## SERVICE INSTRUCTION

# Introduction of wiring harness options with different lengths for ROTAX® Engine Type 912 i (Series)

ATA System: 76-50-00 Wiring Harness

Fig. 1  
Wiring harness

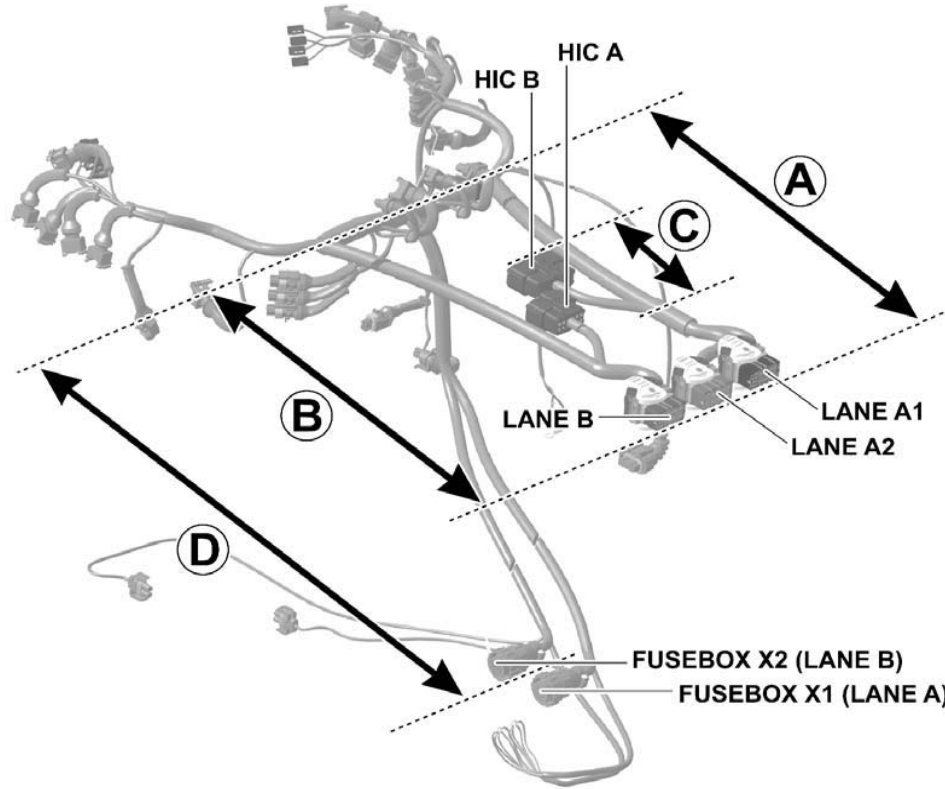
In the course of continuous development, optional wiring harness lengths have been introduced. These wiring harness options allow more precise and convenient location of the ECU/HIC connectors.

Fig.no.	part no.	Qty/ engine	Description	Application
1	New - 665578 Still valid - 665571	1	Wiring harness - Standard	Engine / ECU
1	665573	(1)	(Optional) Wiring harness - Short	Engine / ECU
1	665574	(1)	(Optional) Wiring harness - Special	Engine / ECU
See <a href="#">Fig. 1</a> for harness length details.

PART NO.	DESCRIPTION	LENGTH "A" ECU LANE A1 & A2	LENGTH "B" ECU LANE B	LENGTH "C" HIC A & B	LENGTH "D" FUSEBOX X1 & X2
New - 665578 Still valid - 665571	Wiring harness - Standard	1280 mm (50.4 in.)	1280 mm (50.4 in.)	400 mm (15.7 in.)	580 mm (22.8 in.)
665573	(Optional) Wiring harness -Short	600 mm (23.6 in.)	650 mm (25.6 in.)	400 mm (15.7 in.)	580 mm (22.8 in.)
665574	(Optional) Wiring harness - Special	1150 mm (45.3 in.)	1200 mm (47.2 in.)	400 mm (15.7 in.)	580 mm (22.8 in.)
